DODGE RWD RE TRANSMISSIONS PUSH-IN TRANSMISSION RANGE SENSOR DIAGNOSIS

TRANSMISSION RANGE SENSOR

Figure 2

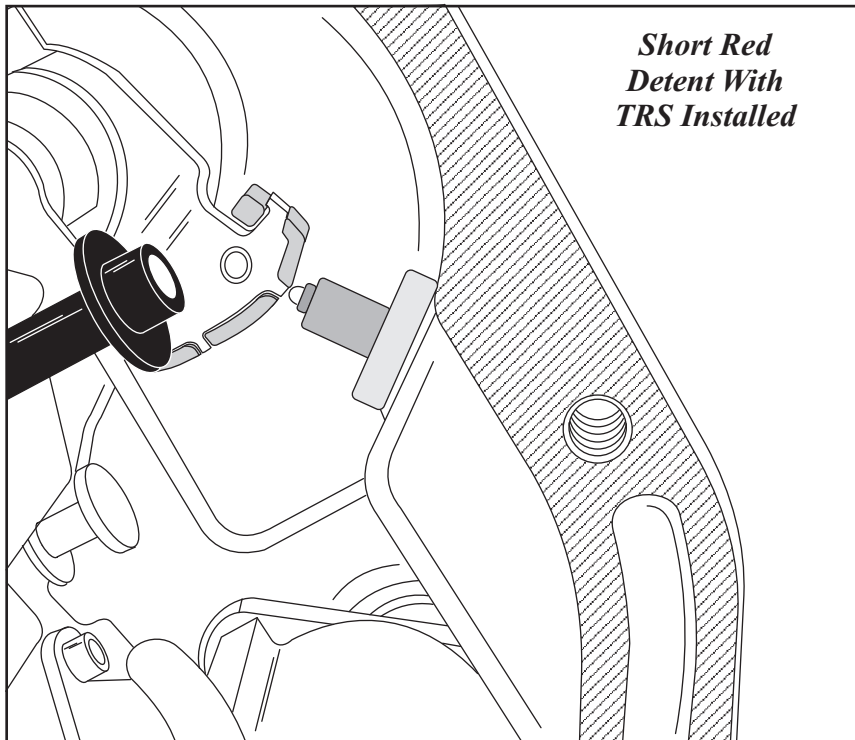
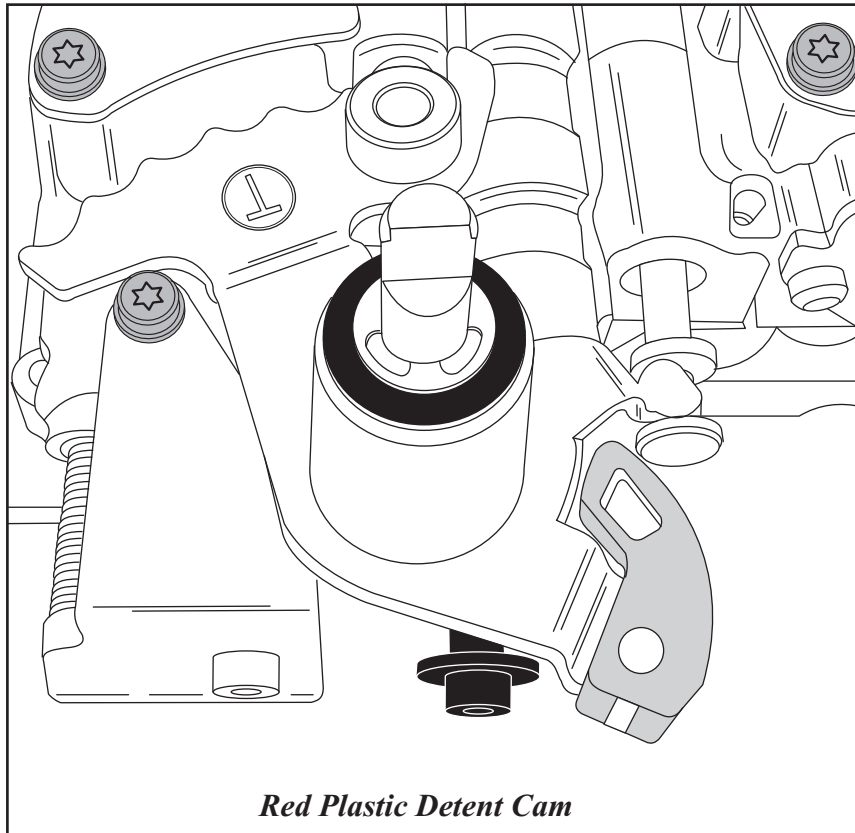
The sensor is mounted in the transmission housing near the valve body, just above the pan rail. It's in the same position as the Park/Neutral switch on other transmissions. The TRS contacts a cammed surface on the manual valve lever (Figure 2). The cammed surface translates the rotational motion of the manual lever into the linear motion of the sensor. The cammed surface on the manual lever is comprised of two parts controlling the TRS signal: The insulator portion contacts the switch poppet when the manual lever is not in PARK or NEUTRAL. The manual lever itself contacts the poppet when the lever is in PARK or NEUTRAL; providing a ground for the signal from the starter relay and the JTEC engine controller.

- (1) The Transmission Range Sensor because it now pushes into a smooth hole in the case and is retained by a hold down bracket and bolt.
- (2) The case because the push-in style case has no threads for the TRS like the previous design case.
- (3) The detent lever on the valve body is shorter to accommodate the longer TRS as seen in Figure 2.

NOTE: Remember to use the correct internal linkage that matches the longer digital sensor as shown in Figure 2.

Figure 5

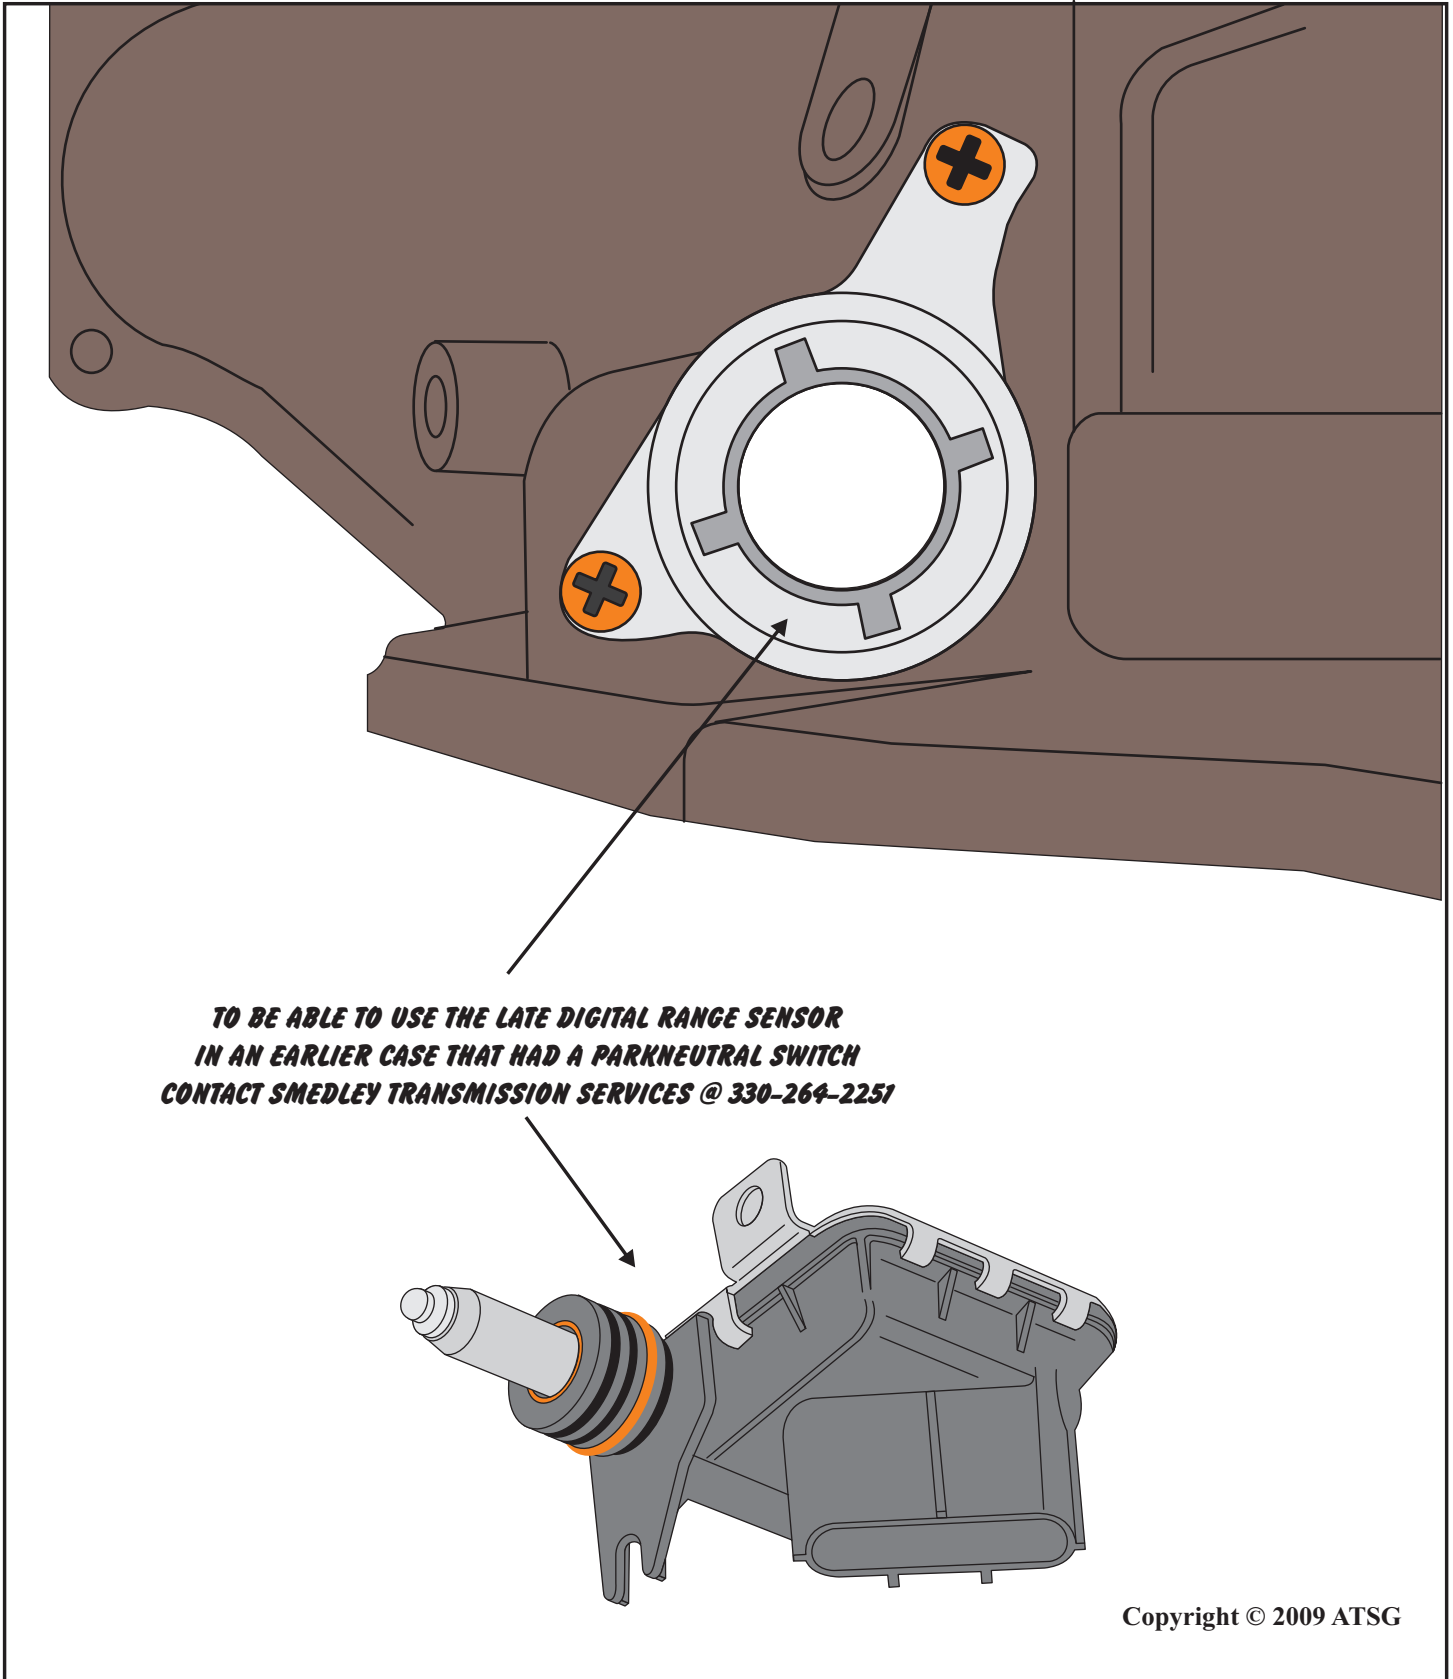
If a case replacement is necessary and all that is available is an early case with the screw-in park/neutral switch, the modified case seen in Figure 5 will accept the later Digital Range Sensor. For more information on this modification contact Smedley Transmission Service at 330-264-2251.
